Product Change Notification

Date Issued :	September 26, 2025	PCN Number :	517365
Reason for Change :	Product Design Change with Obsolescence Change Supplier		
Description of Change :	This notification is to inform you about changes that are being made to the part(s) as identified in the list.		
Assessment of Change :	Reliability Test Report/s		
Planned Implementation Date :	September 30, 2026		
Customer Sample Availability Date:	June 01, 2026		
Last date to request Samples by Customer :	August 01, 2026		
	Please note if Samples are not requested as per Customer Samples Request date, it may take additional 4-6 weeks to arrange Samples.		
Recommended replacement parts :	Please see the attached replacement parts list .xls file.		
Last Time Buy Date for Obsolete Parts :	August 27, 2026		
Last Time Ship Date for Obsolete Parts :	September 27, 2026		
Traceability Code Markings / Date :	New part number

■ CTX-J/C_(J-Japan/C-China) 50 TML

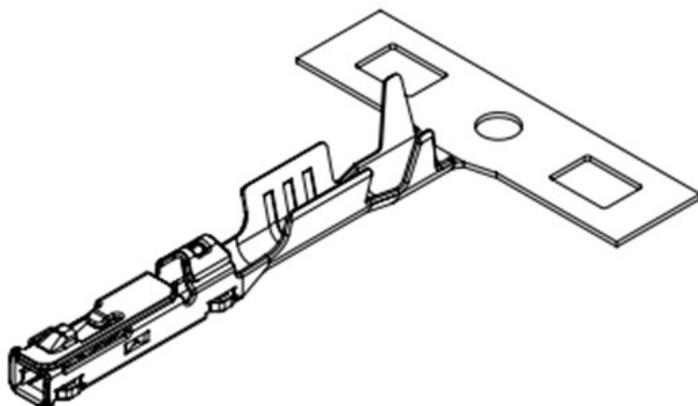
- In response to China EV market growth, we are adding capacity in Molex CD. Robust CTX-C 50 receptacle terminal will be released in Chengdu plant with new invested die and local metal supplier to enhance our supply chain.
- New TML PN/3040210102 will replace old one/5601210102 in mass production.
- Product Impact: no impact to fit or function, terminal design optimized.
- Part Number Impact: see attached impacted parts list
- Qualification Reports and samples available upon request
- PCN will be implemented once all required qualification/ validation has been completed and all necessary approvals have been obtained.

Terminal Design Optimization Detail

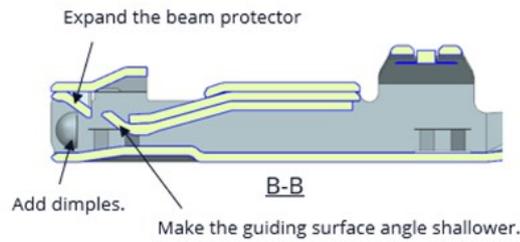
Widen the guiding surface.
